CITY OF WEST LAKE HILLS, TEXAS
NOTICE OF BOARD OF ADJUSTMENT (BOA) REGULAR MEETING
Wednesday, September 10, 2025 at 7:00 PM

3. Consent Agenda Discuss and consider action to approve the August 13, 2025 Regular Meeting Minutes.
4. Land Use 1801 Basin Ledge - Discuss and consider action on a recommendation from ZAPCO on proposed variances

5. Land Use 912 Calithea Road - Discuss and consider action on recommendations from ZAPCO on proposed variances:

6. Land Use 217 Reveille Road - Discuss and consider action on recommendations from ZAPCO on proposed variances:

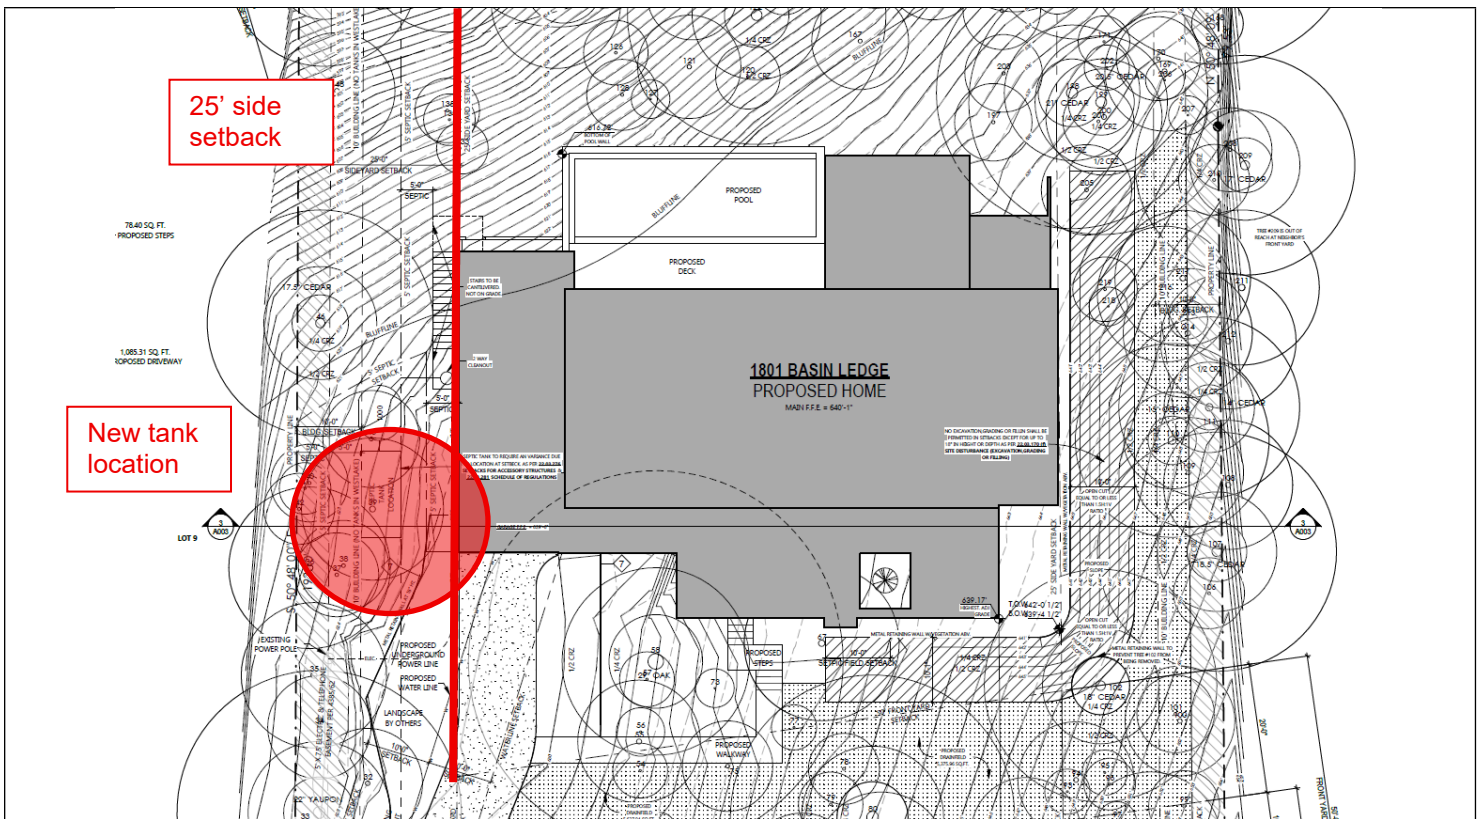
The applicant is requesting a variance to place a new septic tank 15 feet into the 25-foot side setback. The existing septic tank is on the same side of the lot approximately 25 feet from the side property line and out of the side setback.

The proposed footprint of the new structure goes up to the side setback lines on both sides.

Request

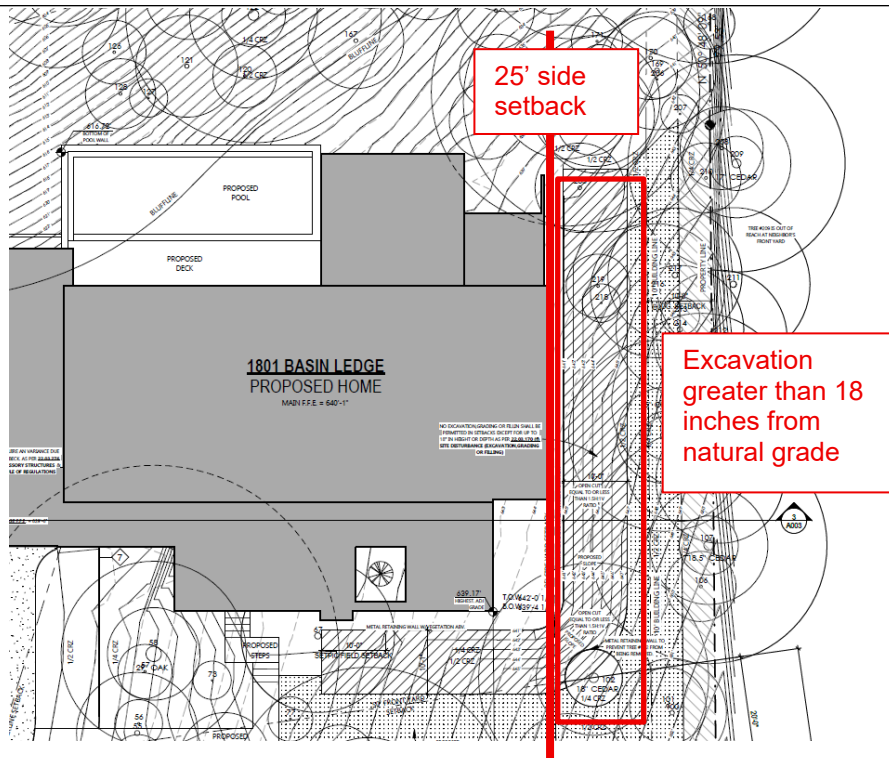
- The applicant's letter does not explicitly call out the grading/excavating more than 18 inches in the setback as a requested variance, but it is listed in their variance justification/findings. The city engineer reviewed the information but is not able to provide a recommendation as it was not listed. Additionally, given the information provided, the city engineer believes that the grading for the driveway will also exceed limits and the house within the buildable area will exceed the Drainage and Erosion Control Manual limits but there is not enough information provided for evaluation (Attachment 4).

2 PROPOSED GRADING SITE PLAN 1" = 20'-0"

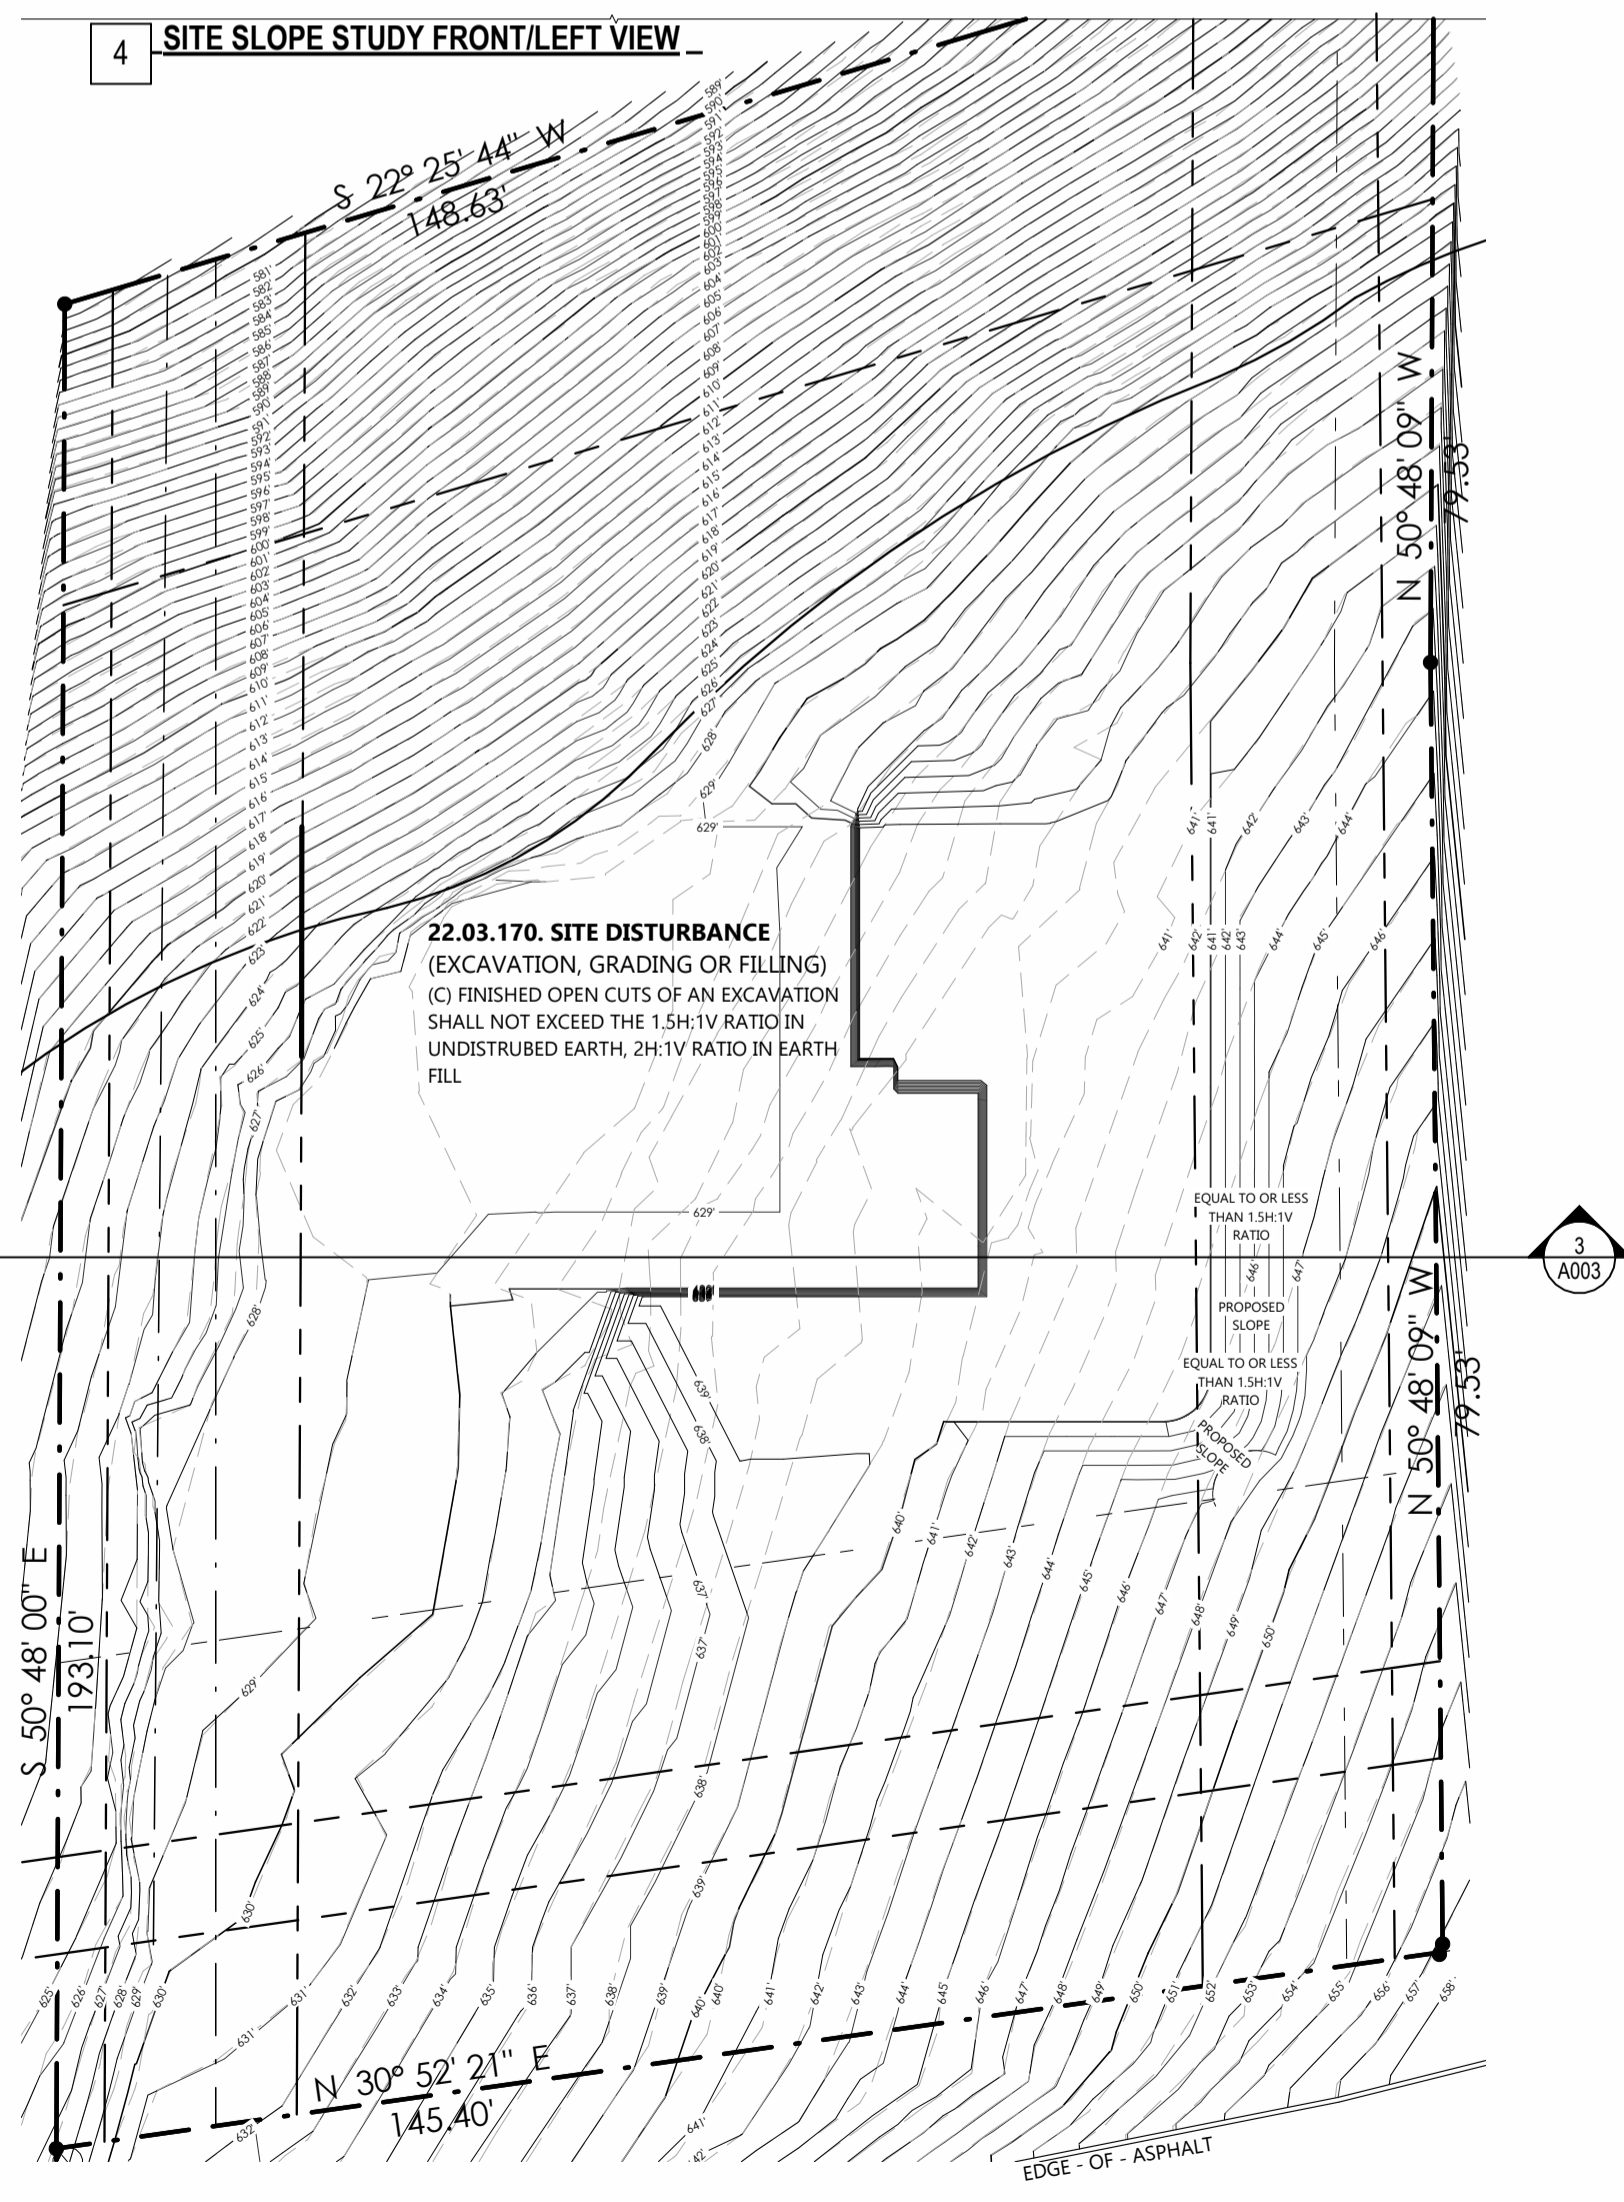
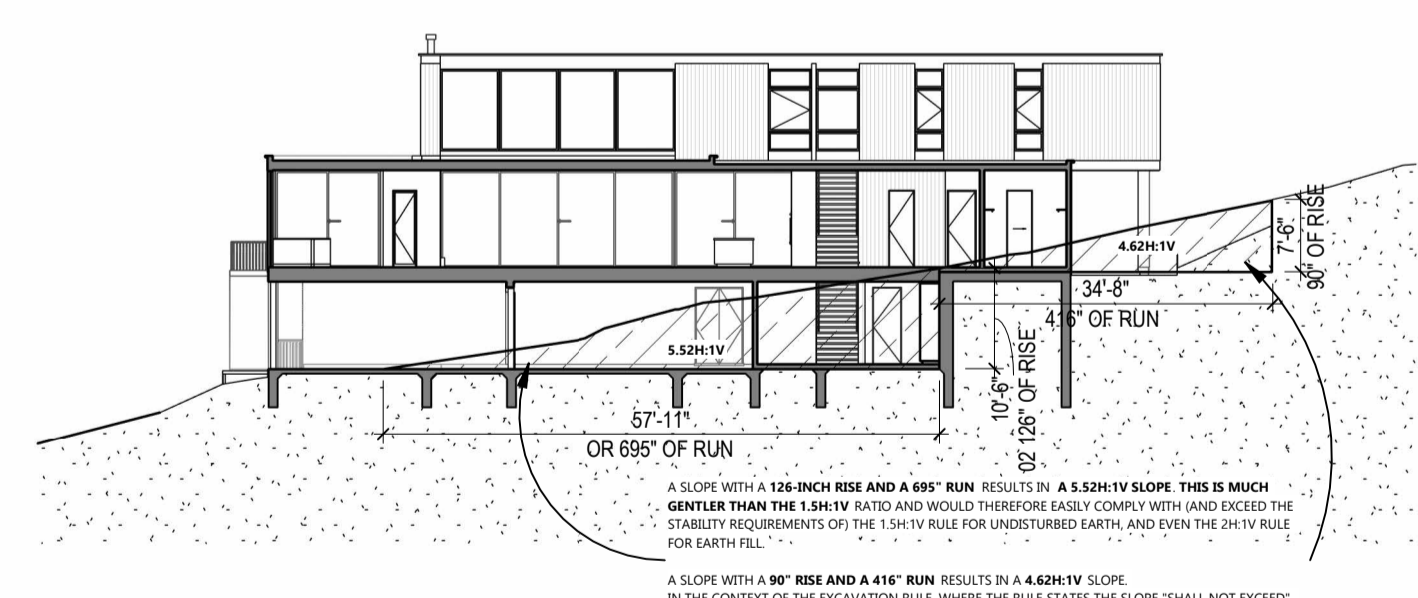
This variance is **Denied**: Please submit proposed grading plan for the drain field to verify it will function as intended and in compliance with design criteria. Additionally, we note that the variance letter only requests relief for the placement of the septic field within the front setback; however, the submitted site plan also shows an encroachment into the 25-foot side yard setback. Provide an updated variance summary letter if this variance request is intended for both the drain field and septic tank within setbacks.

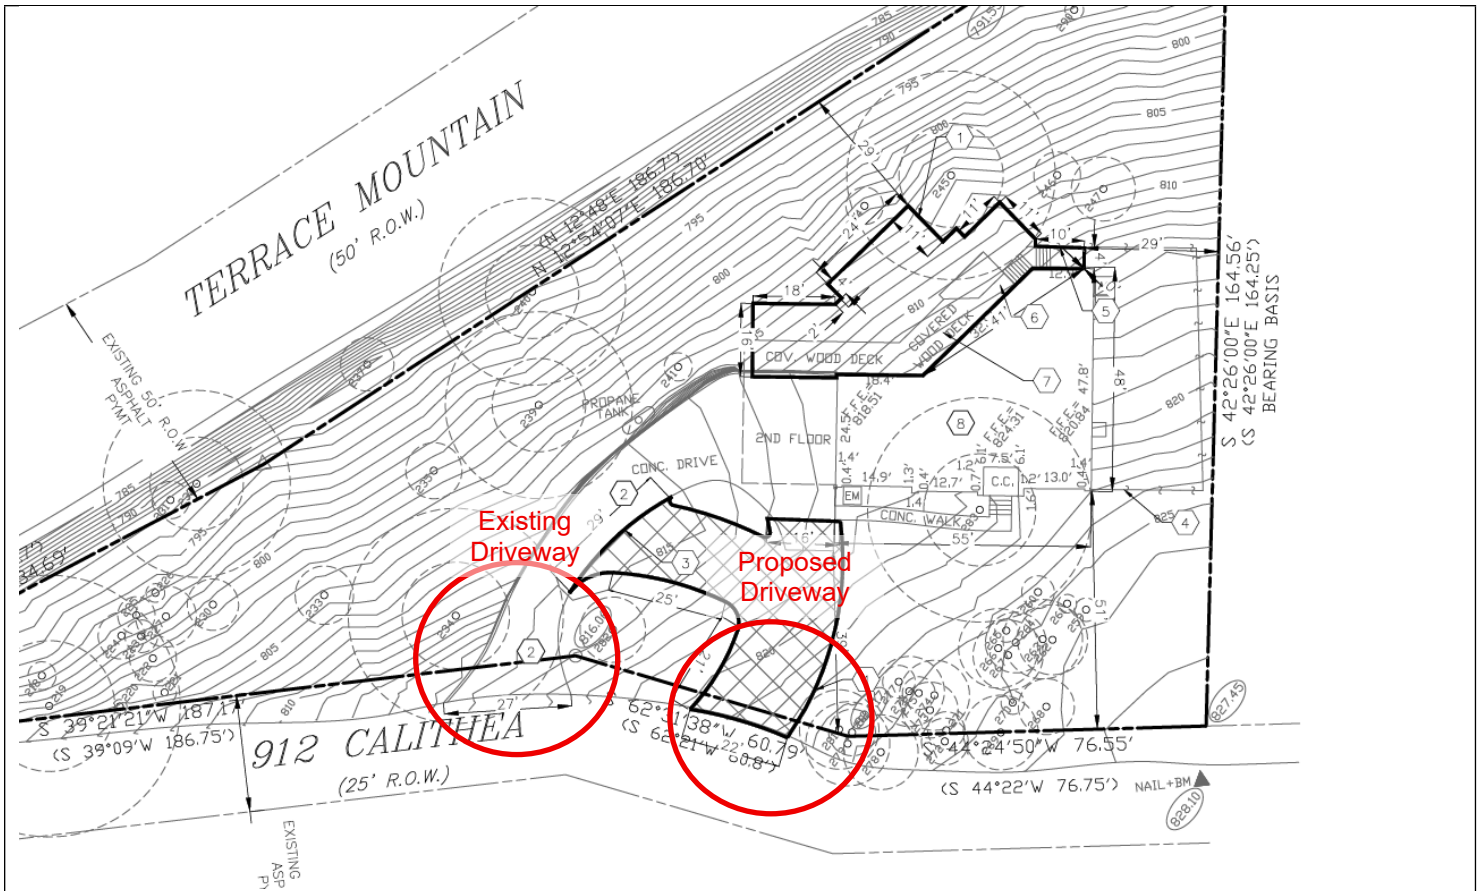
The applicant is requesting to construct a second driveway access to provide a loop driveway for additional parking onsite. The exhibit provided shows the loop area 21 feet from the street edge. Parking areas must be set a minimum of 20 feet from the property line. The applicant has not requested a variance for this, so the plans must be revised to show the driveway setback before a permit can be issued.

Request:

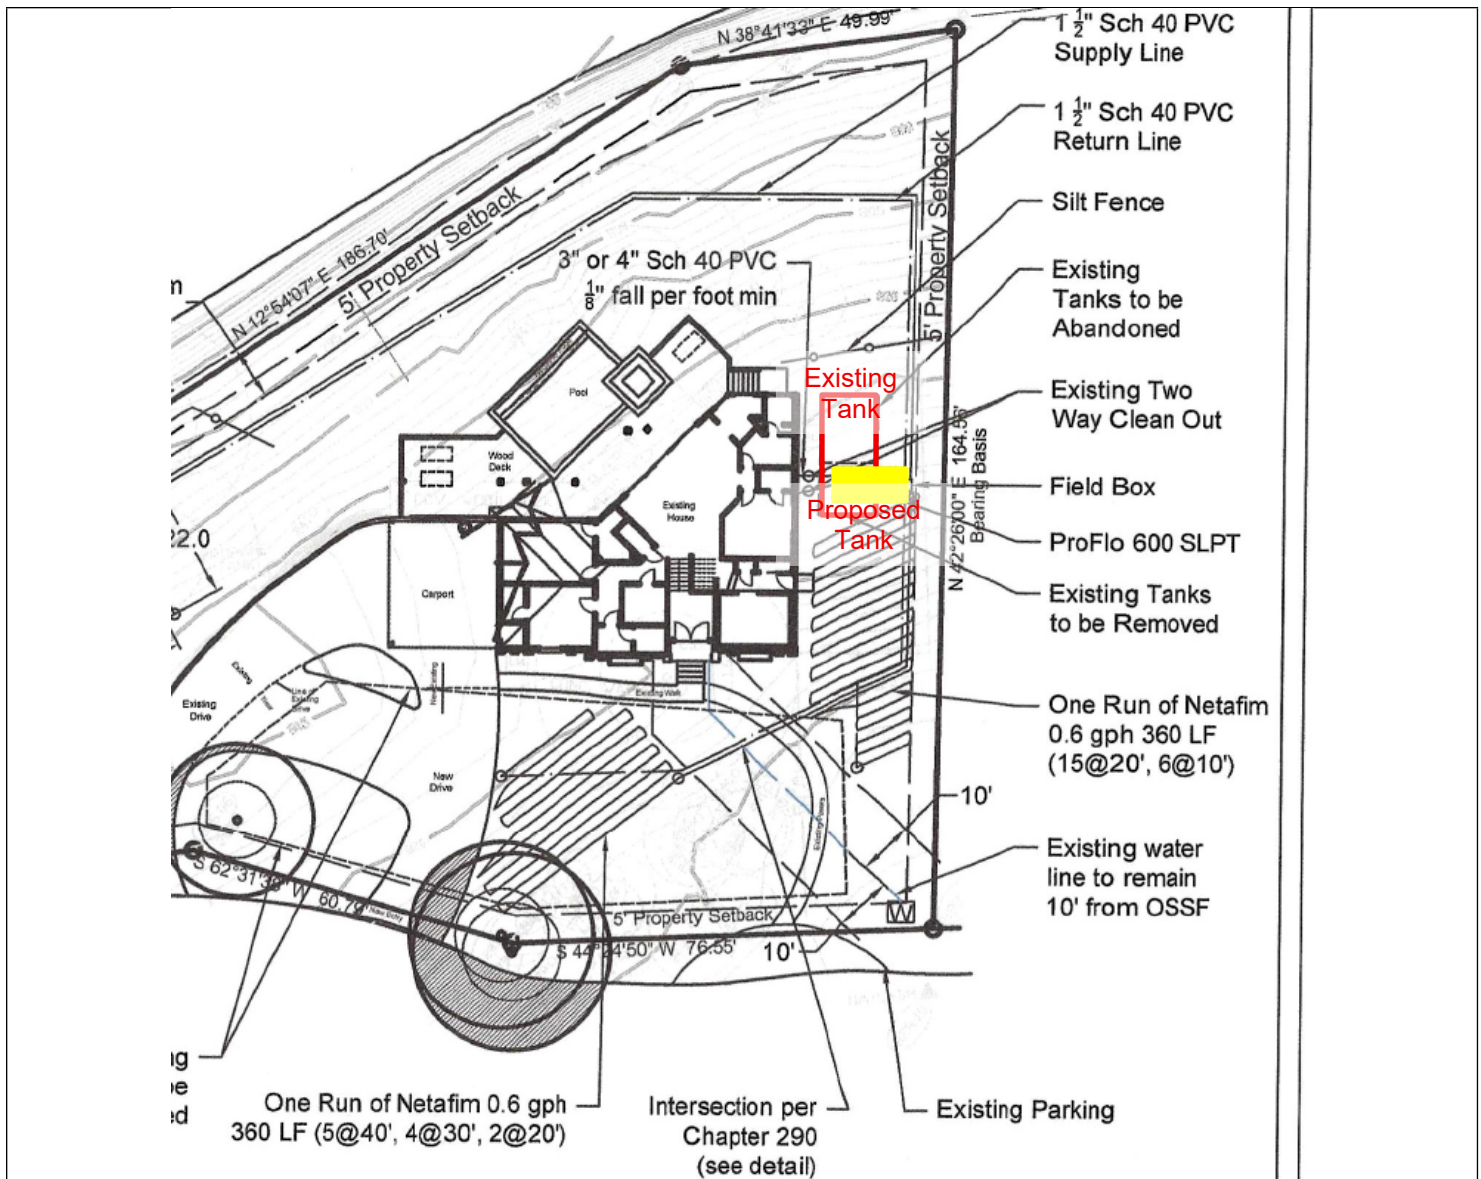
Due to the expansion of the driveway, the septic field will need to be relocated, and the septic tank replaced. The existing tank is encroaching into the side setback approximately 15 feet. The proposed tank would encroach approximately 20 feet.
